## **Proposal for a new series of amendments to UN Regulation No. 48 (Installation of lighting and light-signalling devices)**

The text reproduced below was prepared by the GRE-IWG SLR as requested by GRE at its 81<sup>st</sup> session (see ECE/TRANS/WP.29/GRE/81, Par. 10). This proposal is based on document ECE/TRANS/WP.29/GRE/2019/03 taking into account the agreed modifications to the diagram introduced with GRE-81-21 (see ECE/TRANS/WP.29/GRE/81, Annex II) The modifications to the existing text of UN Regulation No. 48 are marked in **bold** for new and ~~strikethrough~~ for deleted characters.

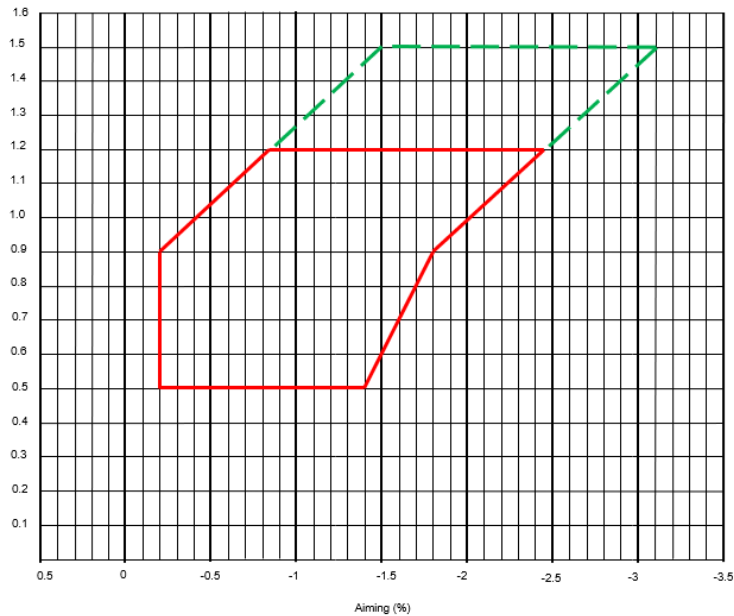
**$0.5 \text{ m} \leq h \leq 0.9 \text{ m}$ :**

**the minimum vertical inclination limit is -0.2 %**

**and**

**the maximum vertical inclination limit increasing linearly, in relation to the dipped-beam headlamp mounting height, from - 1.4 % to - 1.8 %;**

**$0.9 \text{ m} < h \leq 1.2 \text{ m}$ :**

**the minimum vertical inclination limit increasing linearly, in relation to the dipped-beam headlamp mounting height, from - 0.2 % to - 0.85 %**

**and**

**the maximum vertical inclination limit increasing linearly, in relation to the dipped-beam headlamp mounting height, from - 1.8 % to - 2.45 %;**

**$1.2 \text{ m} < h \leq 1.5 \text{ m}$ :**

**the minimum vertical inclination limit increasing linearly, in relation to the dipped-beam headlamp mounting height, from - 0.85 % to - 1.5 %**

**and**

**the maximum vertical inclination limit increasing linearly, in relation to the dipped-beam headlamp mounting height, from - 2.45 % to - 3.1 %;**

The above limits and the initial aiming values are summarized in the diagram below.

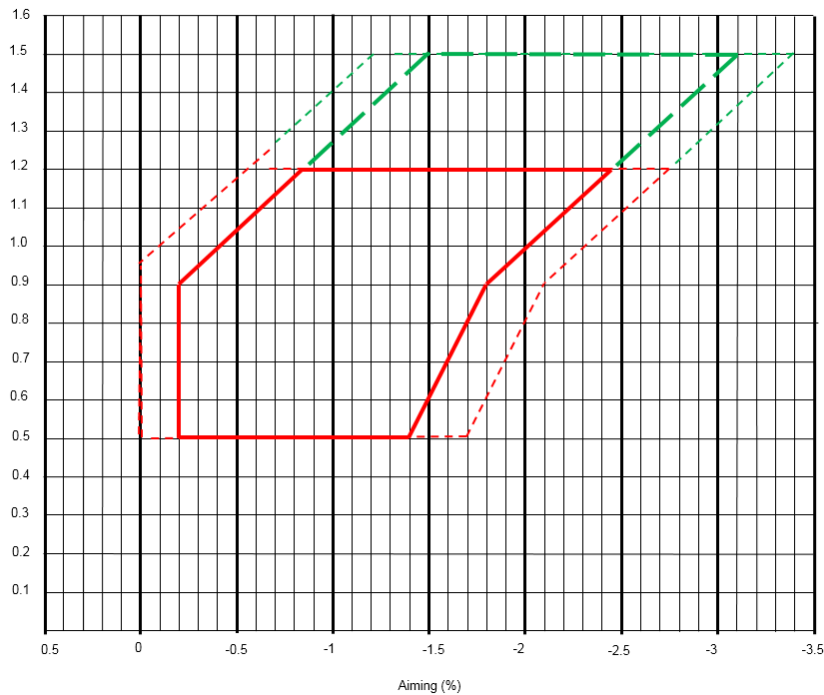
**$0.5 \text{ m} \leq h \leq 0.9 \text{ m}$**

**0% minimum vertical inclination and -1,7 % to -2,1 % maximum vertical inclination, in relation to the dipped-beam headlamp mounting height.**

**$0.9 \text{ m} < h \leq 1.2 \text{ m}$ :**

**0% to -0,55 % minimum vertical inclination increasing linearly, in relation to the dipped-beam headlamp mounting height and  
-2,1 % to -2,75 % maximum vertical inclination limit increasing linearly, in relation to the dipped-beam headlamp mounting height**

**$1.2 \text{ m} < h \leq 1.5 \text{ m}$ :**

**-0.55 % to -1.2 % minimum vertical inclination increasing linearly, in relation to the dipped-beam headlamp mounting height and  
-2.75 % to -3.4 % maximum vertical inclination limit increasing linearly, in relation to the dipped-beam headlamp mounting height.**
